ADDENDUM 1

ADDENDUM DATE: April 9th, 2019

PROJECT: OCSC Expansion - Phase 1, Seymour Center
2551 Homestead Rd.
Chapel Hill, NC 27516

The following is a list of changes that have been made to the plans since the issuance of bid documents. These changes are as a result of Town review comments.

C8-00

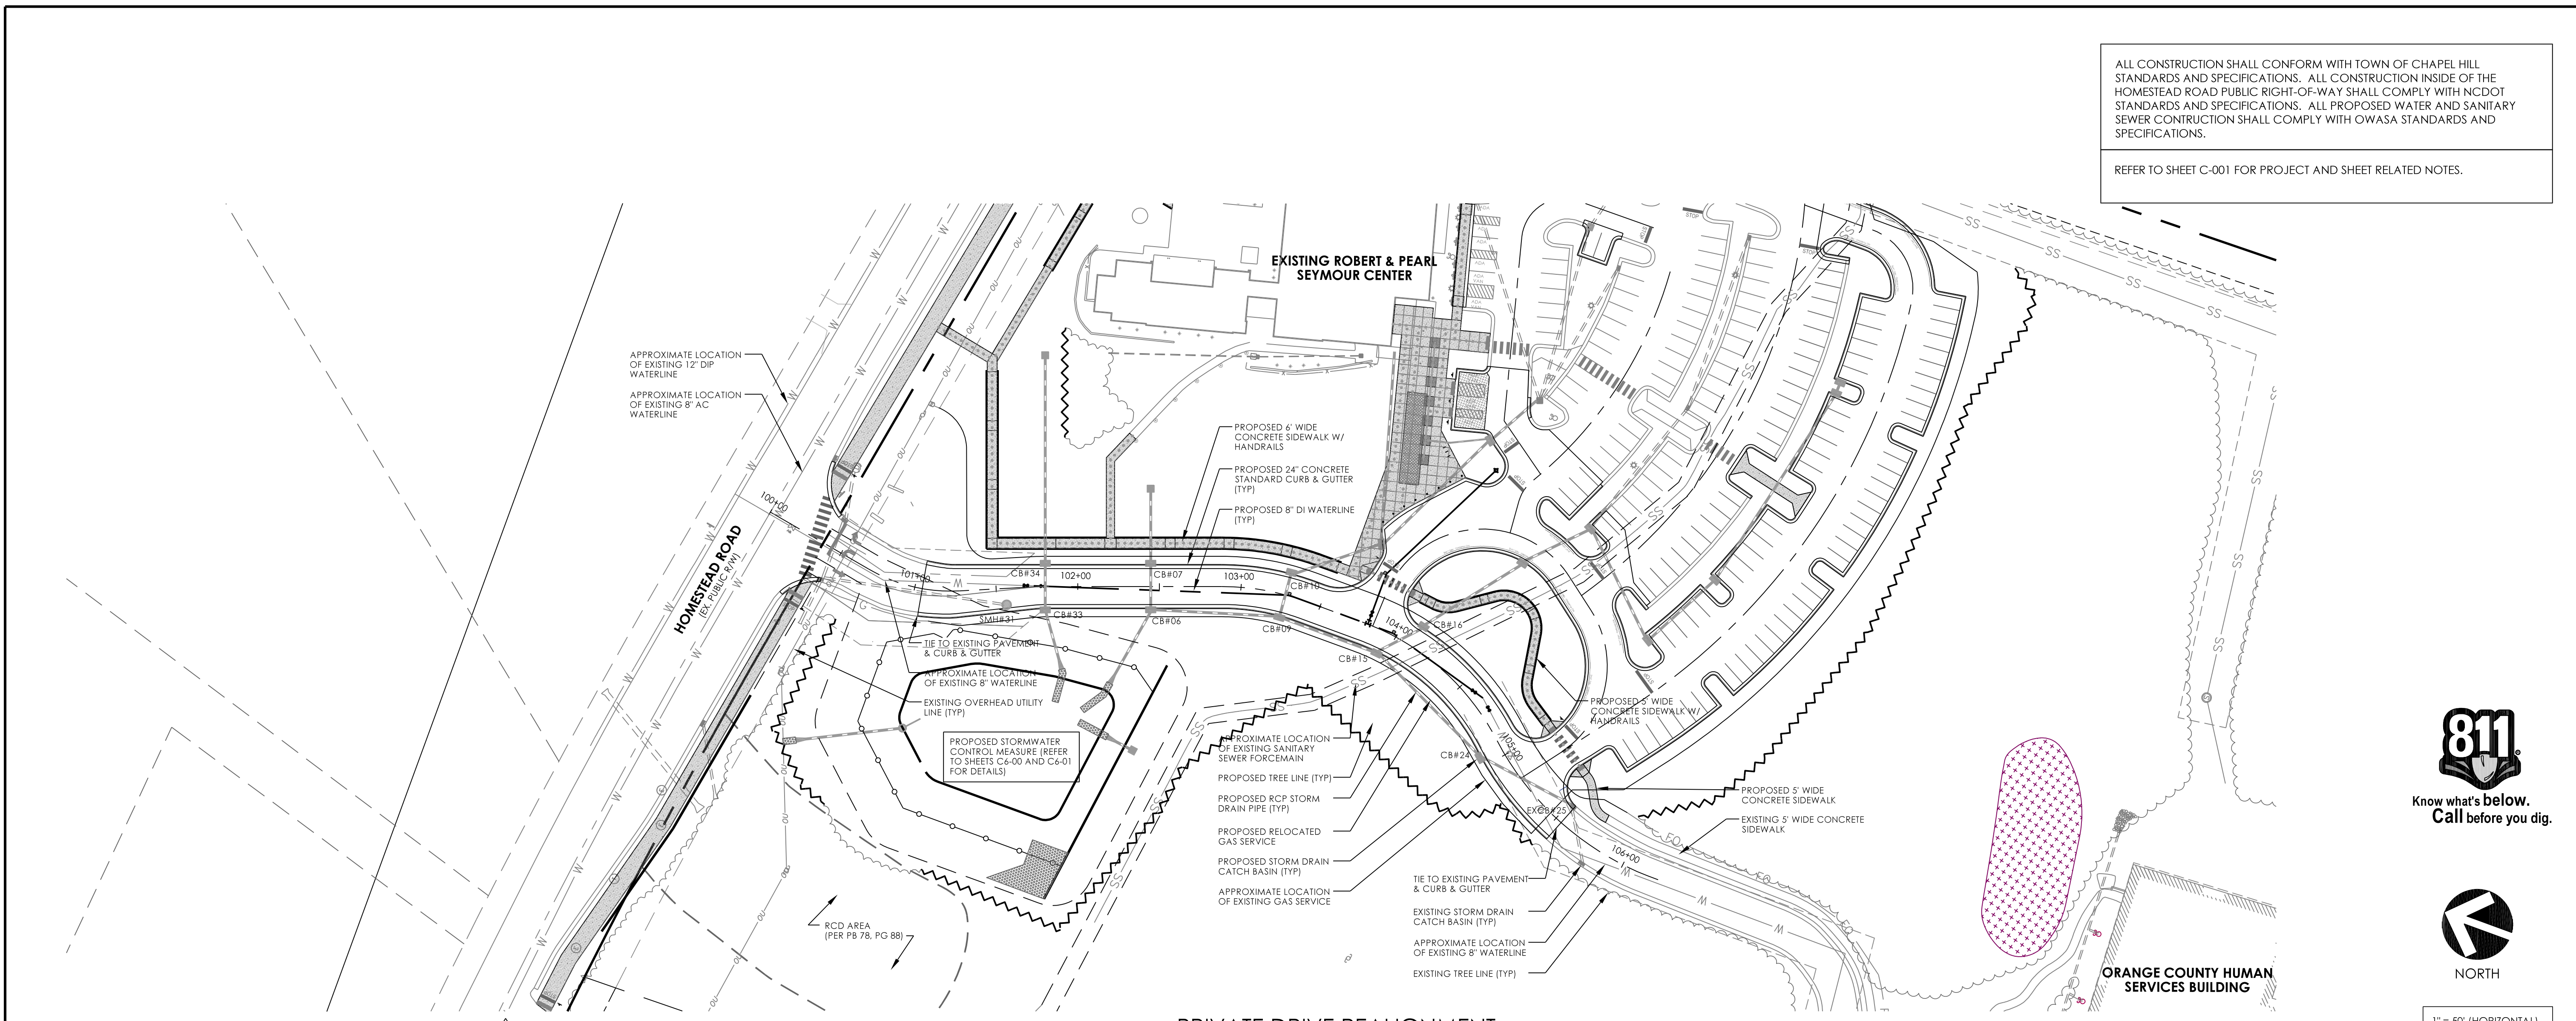
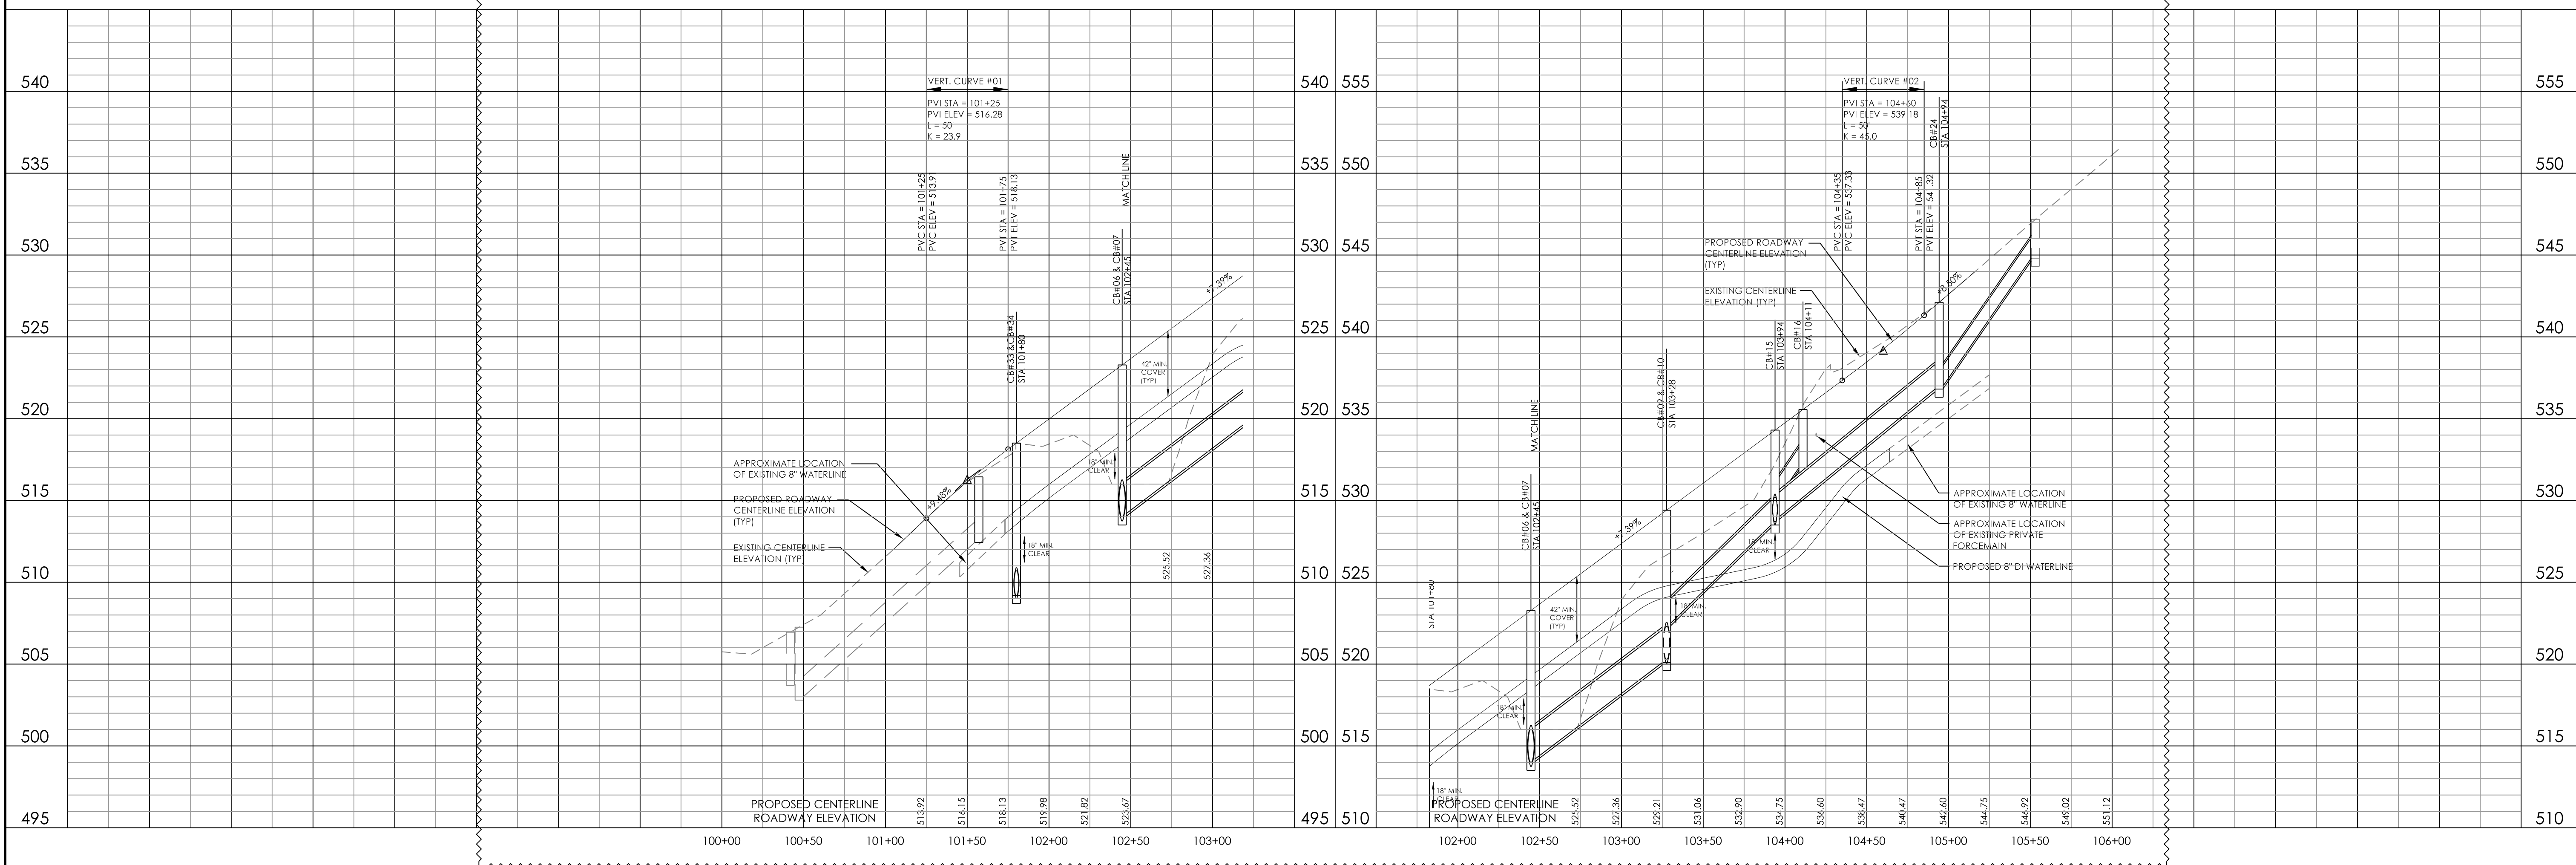
5. Several sections of the storm drainage system on site have been revised including elevations and pipe sizes. (Refer to sheets C5-30 and C8-00)

C9-21

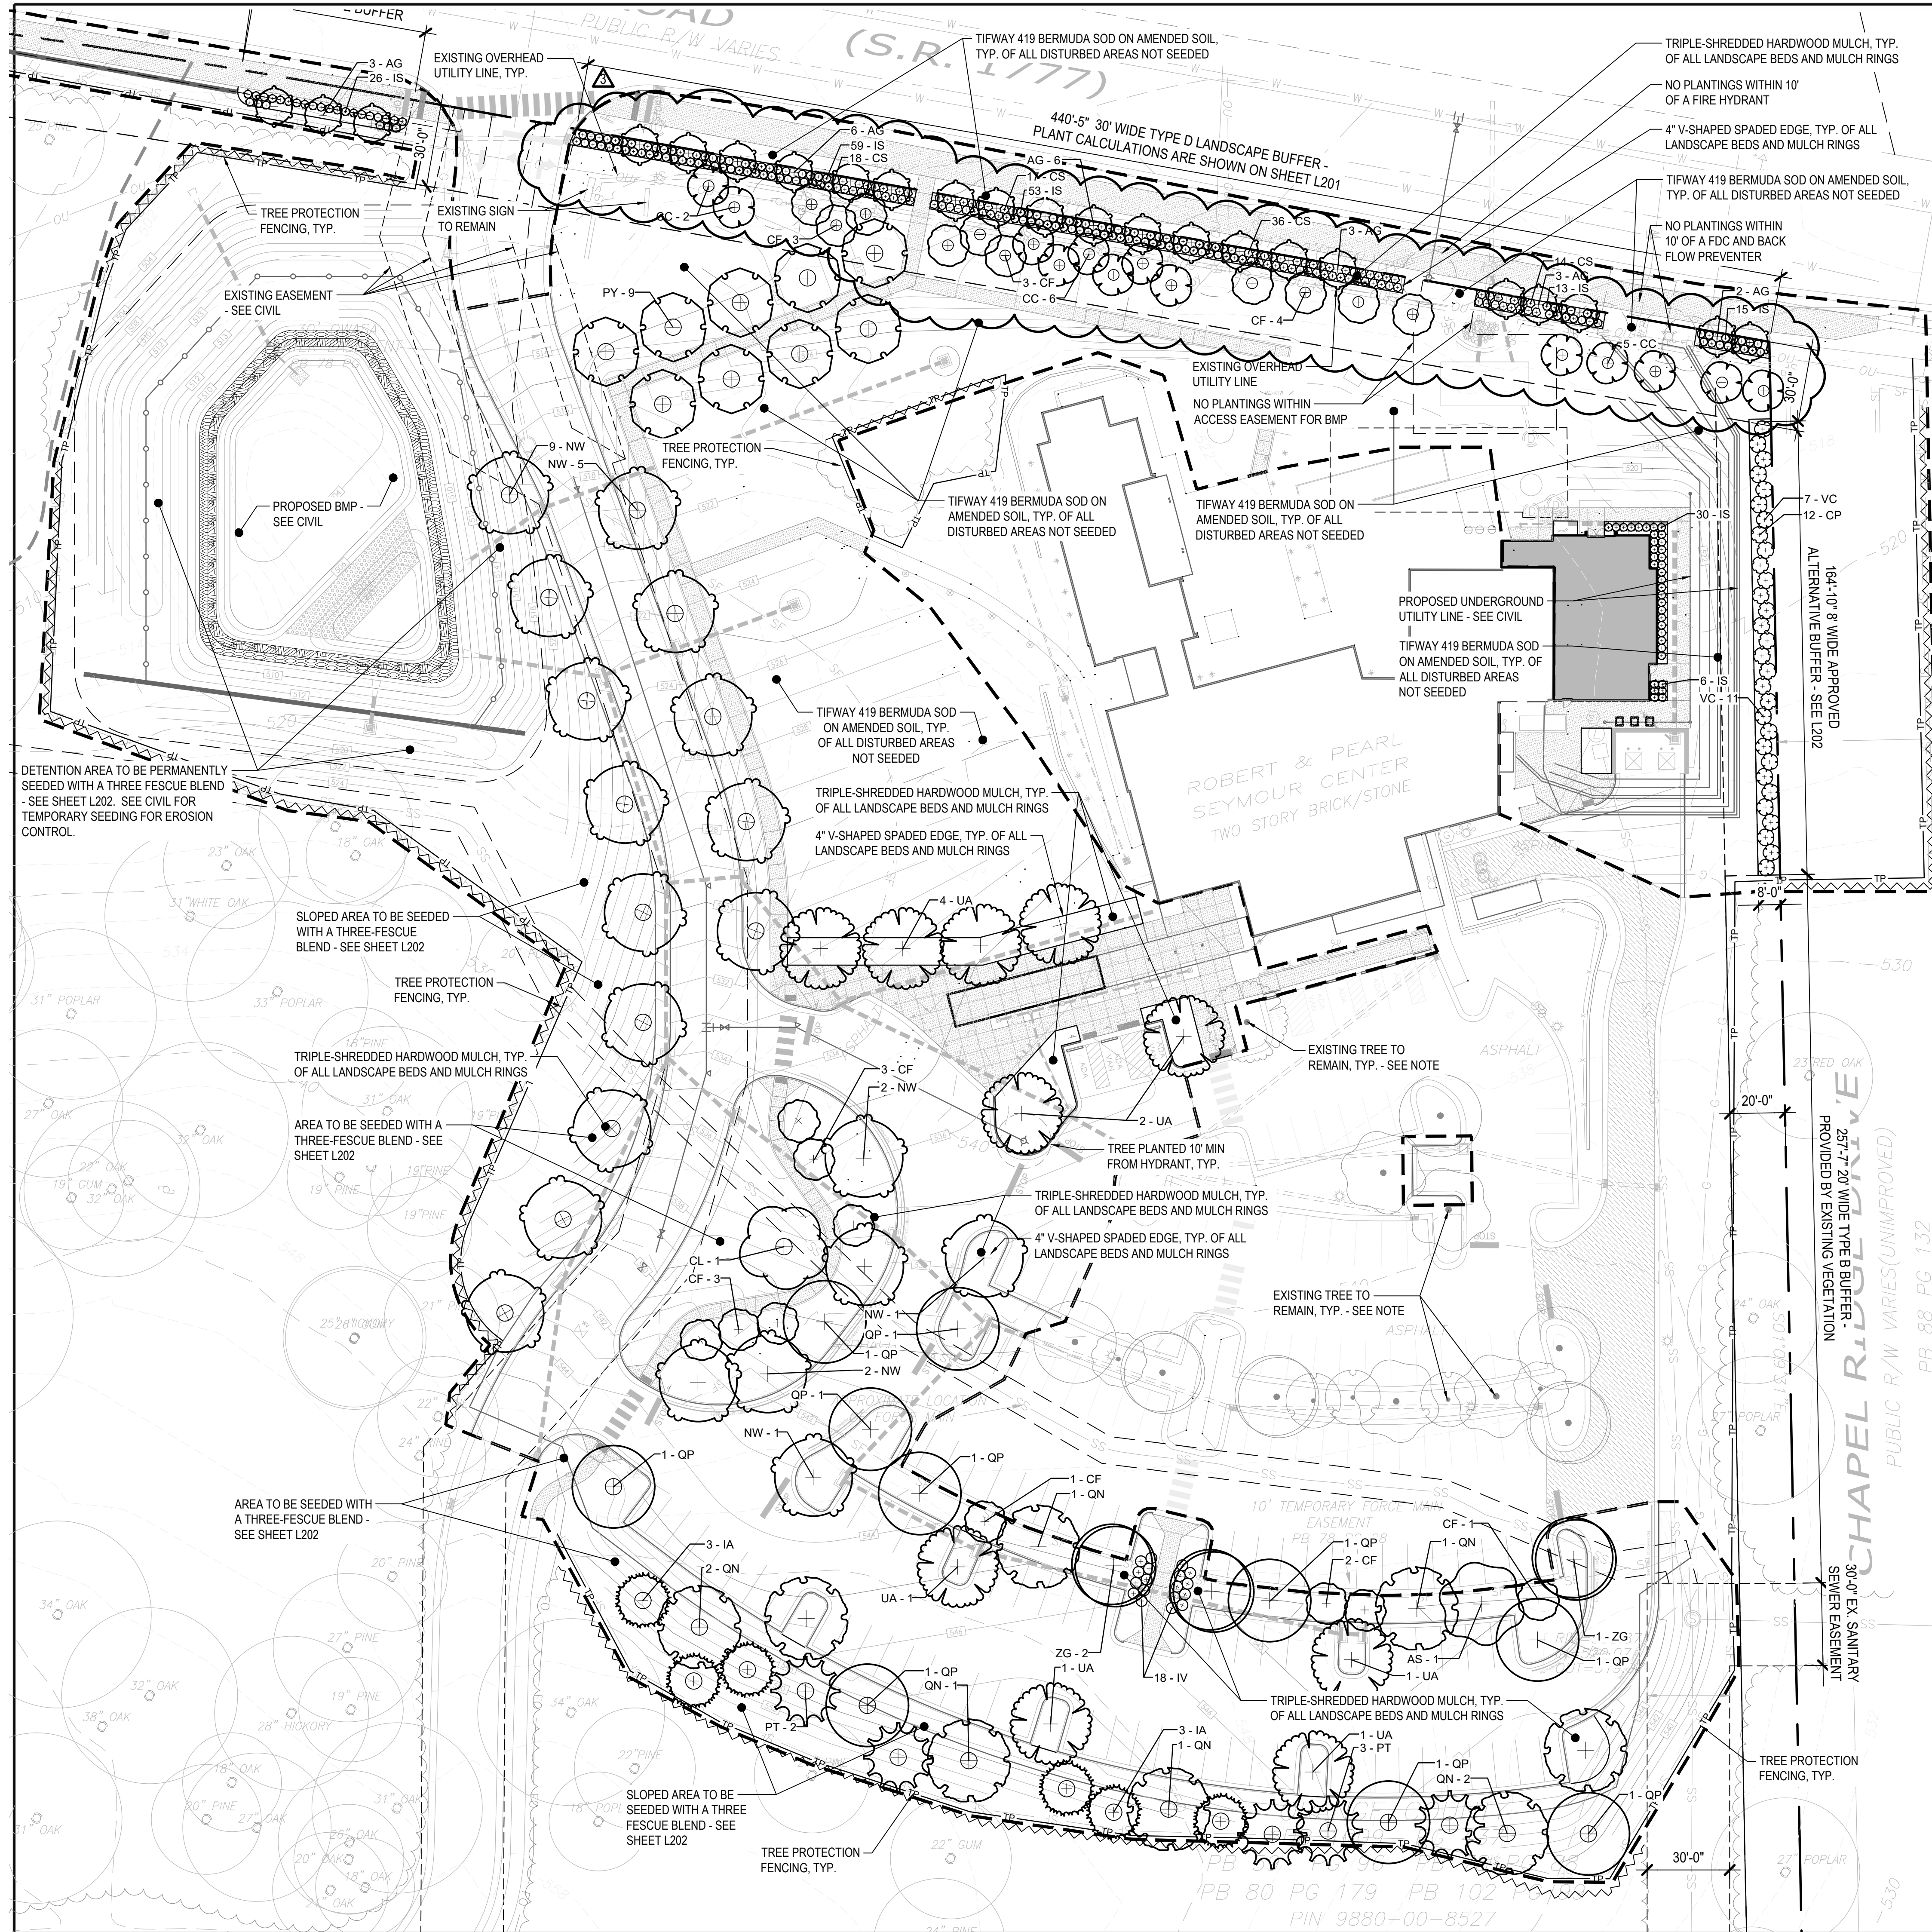
6. The rip-rap dissipator table on sheet C9-21 has been modified. (Refer to sheet C9-21)
7. The draw down orifice on the stormwater pond riser structure has been modified. (Refer to sheet C6-10)
